Addendum No. 01 INVITATION TO BID.: B25/26-01 Building 2400 & 3800 Demolition Project at Chabot College

Subject: **Chabot College Building 2400 & 3800 Demolition and Sitework**
Chabot Las Positas Community College District
DSA App #01-122568
Aedis Project No. 2025029

ADDENDUM NO. 1

SHEET # **AD#1 -**

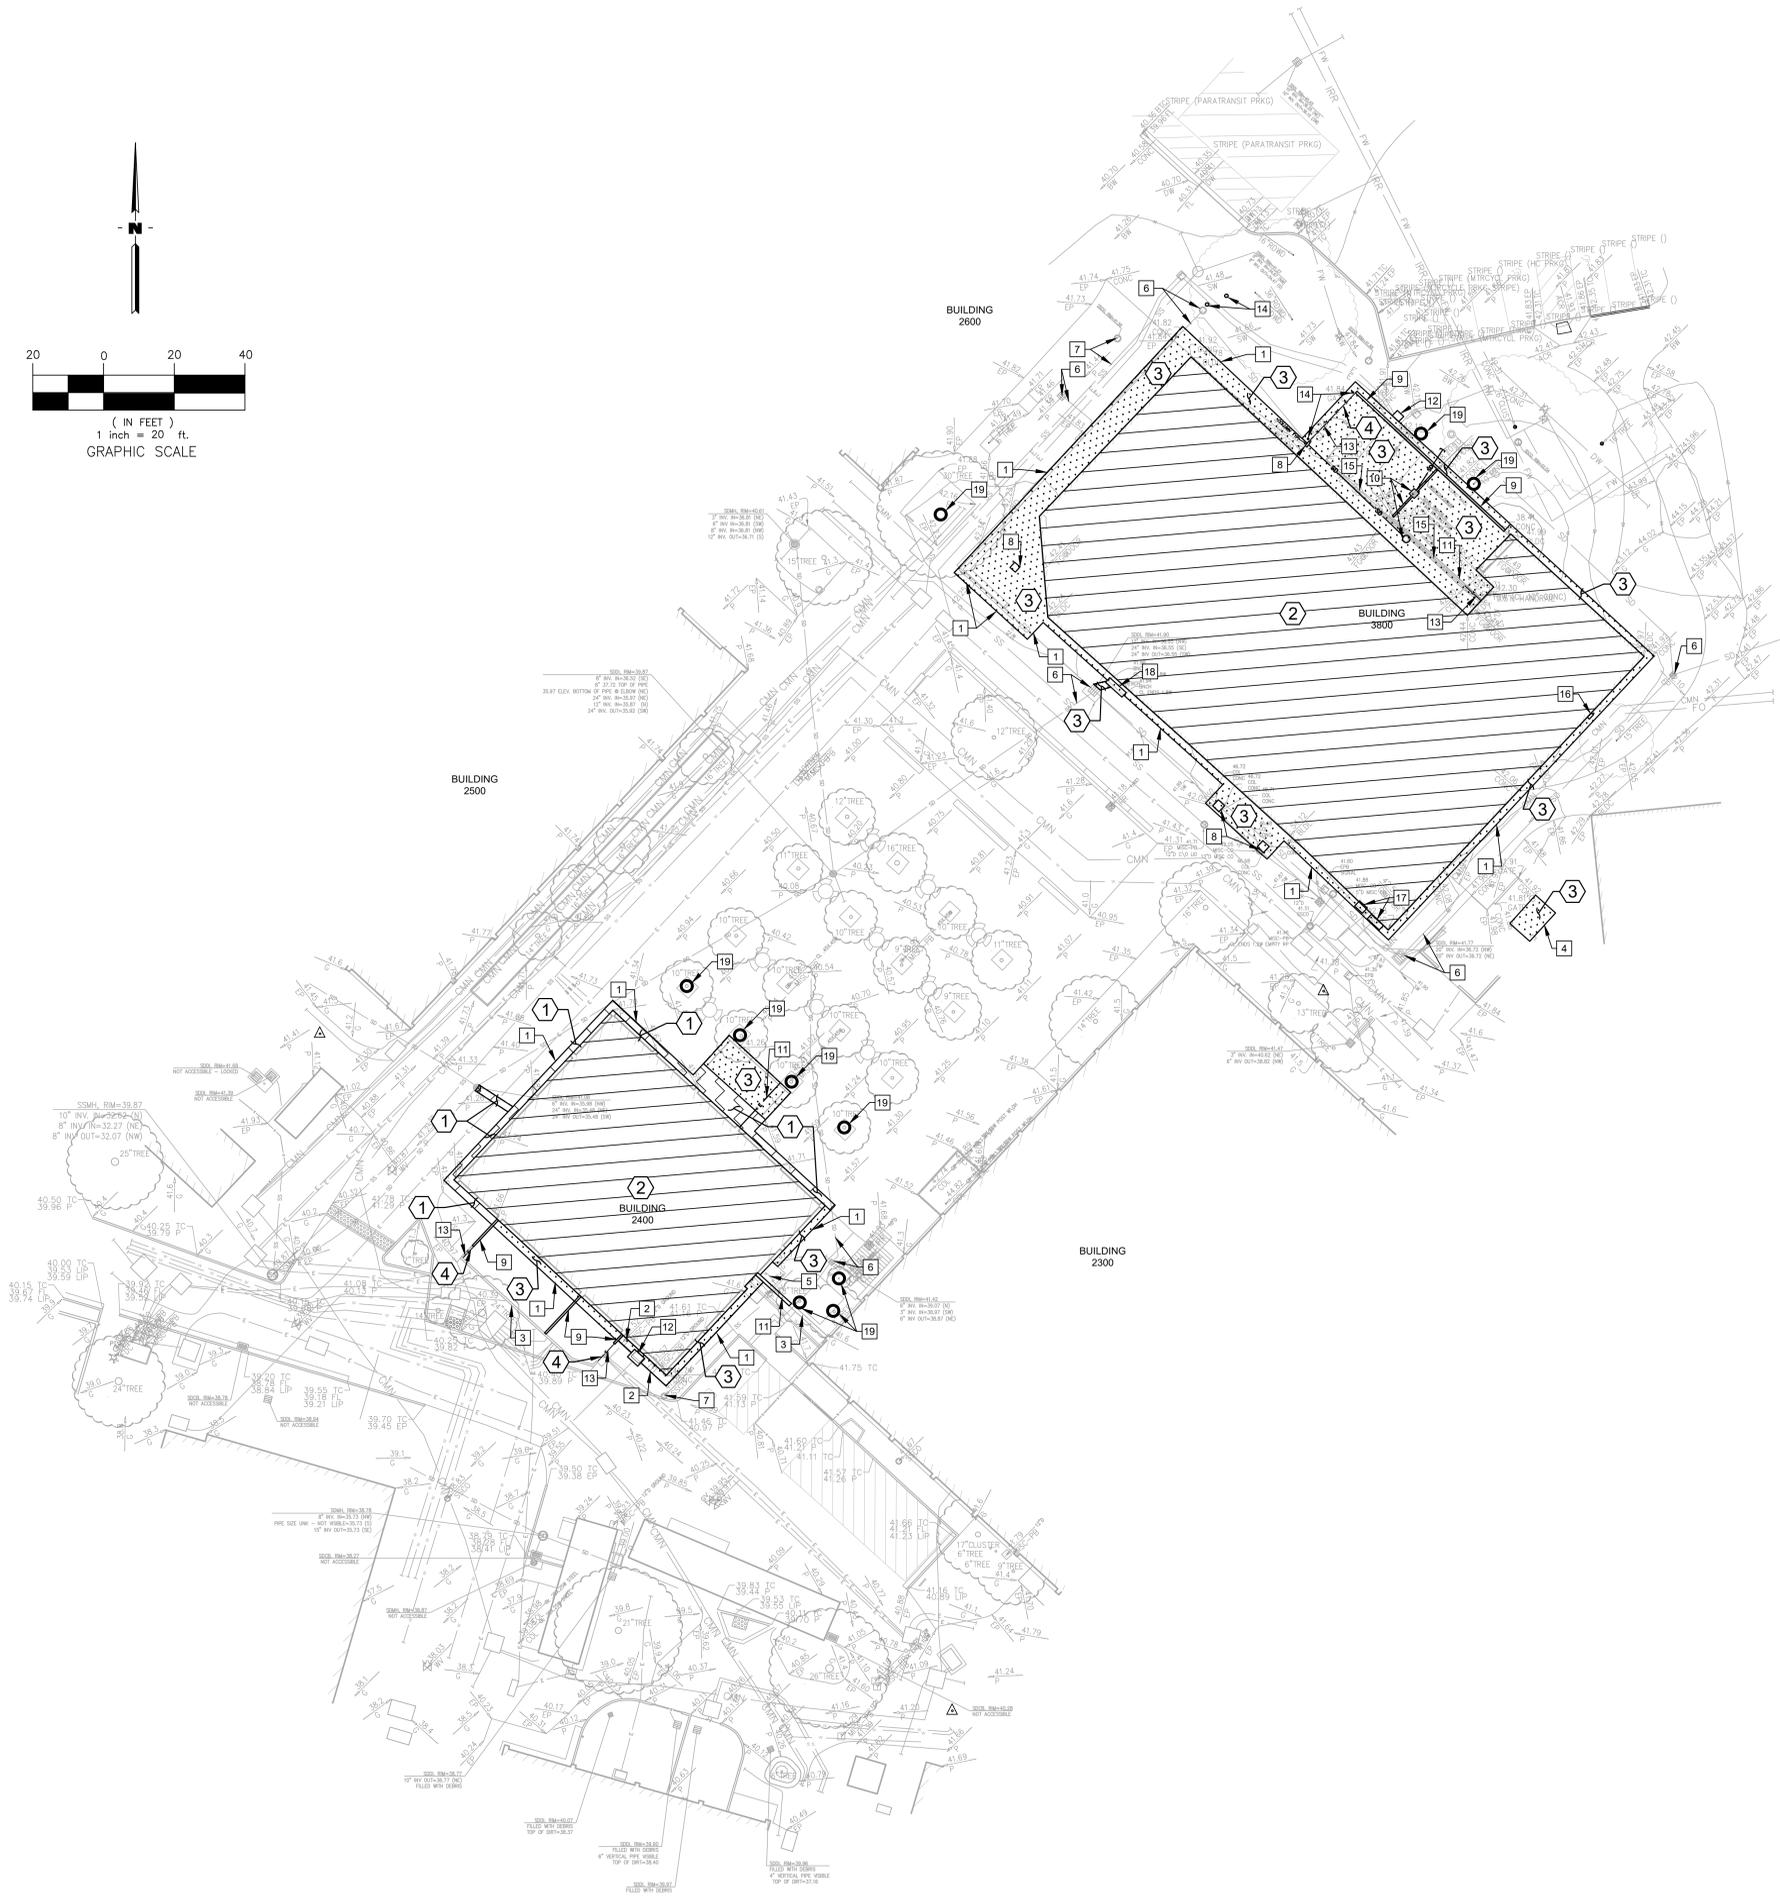
RESPONSE 2: *Utility pedestal to remain. Demo contractor to sawcut and proceed with caution when working around the pedestal. Refer to sheet AD#1-C1.1 and ED1.01 for revised notes and clarification.*

2 – Question: The utility pedestal near loading dock at 3800 was to remain. It would be best not to touch it due to parking lot lights being fed by the pedestal.

2 – Response: Utility pedestal to remain. Demo contractor to sawcut and proceed with caution when working around the pedestal. Refer to sheet AD#1-C1.1 and ED1.01 for revised notes and clarification.

9	REMOVE WALL & FOUNDATION.	
10	REMOVE TRENCH DRAIN AND AREA DRAIN INLET CAP AT EXTEND OF REMOVAL.	
11	REMOVE ELECTRICAL PLUG, SAFE OFF, CAP, S.E.D.	
12	UTILITY PEDESTAL TO REMAIN. DEMO CONTRACTOR IS TO SAWCUT AND PROCEED WITH CAUTION WHEN WORKING AROUND THE PEDESTAL AND UNDERGROUND CONDUIT TO THE PEDESTAL, S.E.D.	
13	REMOVE GATE / FENCE.	
14	REMOVE BOLLARD AND FOUNDATION.	
15	REMOVE HANDRAIL AND FOUNDATION.	
16	(E) WALL MOUNT IRRIGATION CONTROLLER (RAIN MASTER EVOLUTION DX2) TO BE REMOVED FROM WALL MOUNT ENCLOSURE AND RELOCATED INTO NEW PEDESTAL MOUNT ENCLOSURE ASSEMBLY BY CONTRACTOR. CONTRACTOR SHALL RUN NEW IRRIGATION WIRES FROM NEW PEDESTAL MOUNT IRRIGATION CONTROLLER TO EXISTING WALL MOUNTED CONTROLLER AND SPLICE EXISTING REMOTE CONTROL WIRES. SPARE REMOTE CONTROL WIRES, COMMON WIRE AND SPARE COMMON WIRE IN A SPLICE BOX AT THE BASE OF THE WALL MOUNTED CONTROLLER. REFER TO C2.1 - GRADING PLAN FOR FOR LOCATION OF NEW PEDESTAL MOUNT IRRIGATION CONTROLLER.

SHEET # AD#1 -
C2.1

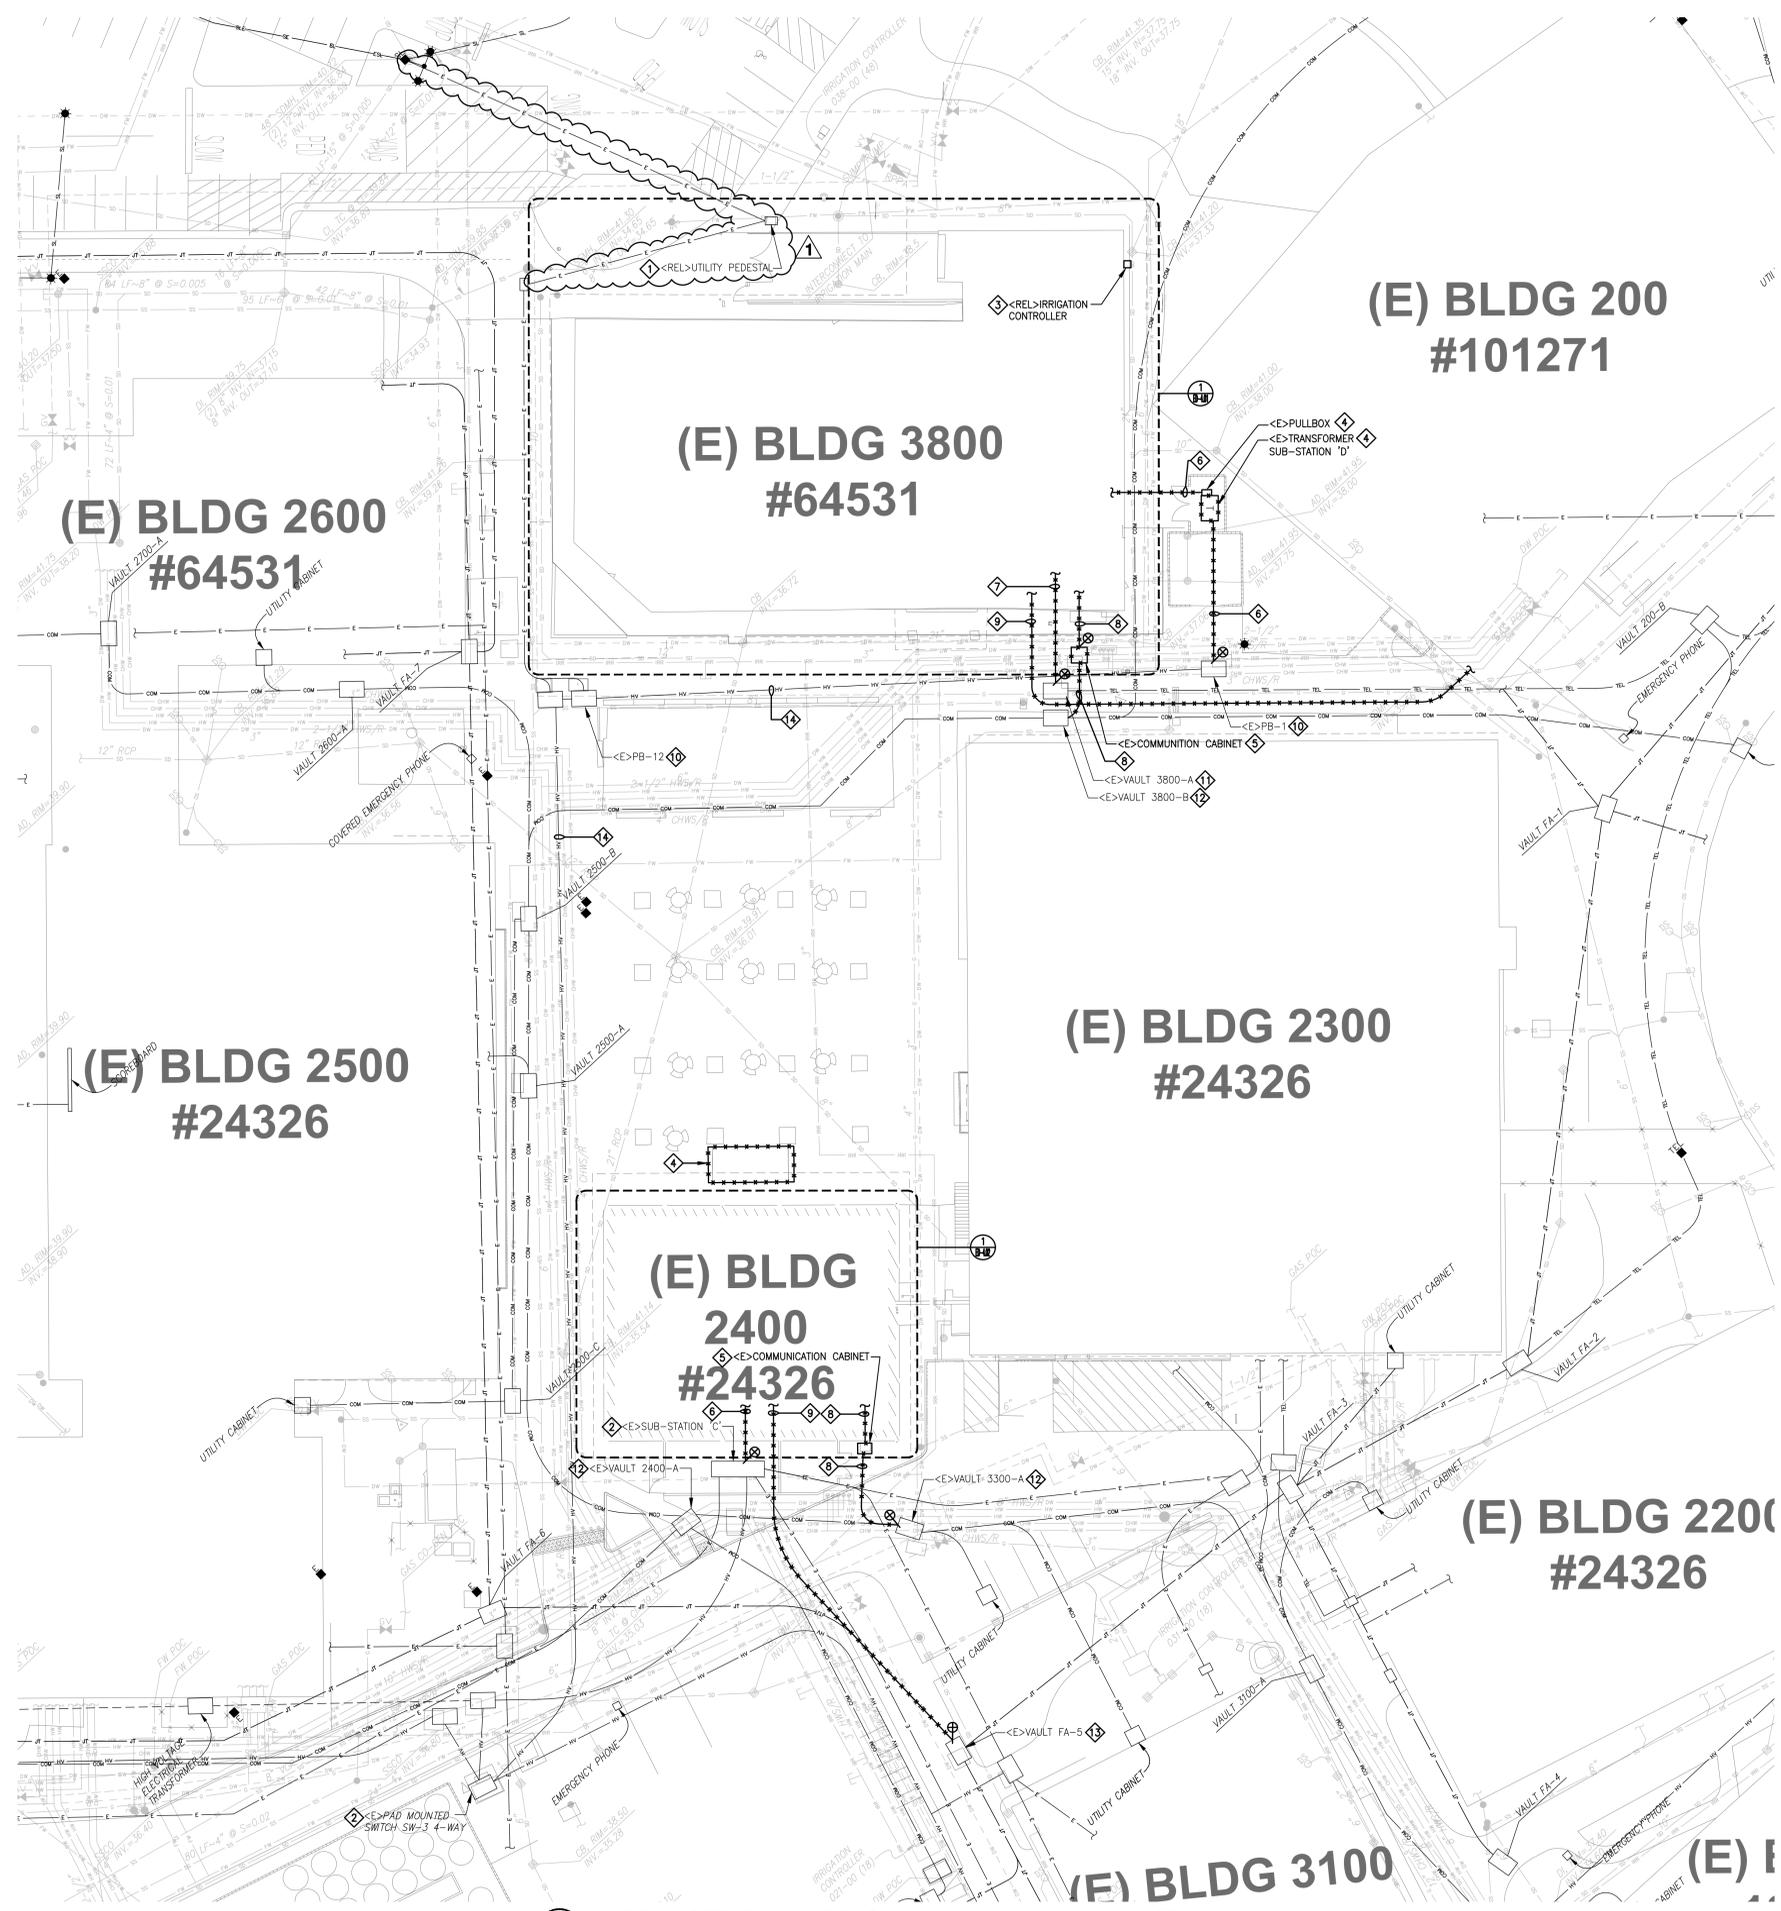
3- Question: Sheet E1.01, irrigation pedestal, why is it showing power running to the utility pedestal in front of B3800?

3-Response: Provide and install irrigation pedestal as shown clouded on attached sheets AD#1 – E1.01 and C2.1

KEYNOTE	DETAIL NAME	SYMBOL	DETAIL REFERENCE
1	ASPHALT PAVING		1/ C3.1
2	AGGREGATE BASE		3/ C3.1
3	12" STORM INLET		4/ C3.1
4	CONCRETE PAVING		5/ C3.1
	JOINT EXPANSION		
	JOINT SCORE		
5	HEADERBOARD		6/ C3.1
6	IRRIGATION CONTROLLER - PEDISTAL MOUNT REFER TO ELECTRICAL PLANS FOR POWER AND DATA.		7/ C3.1
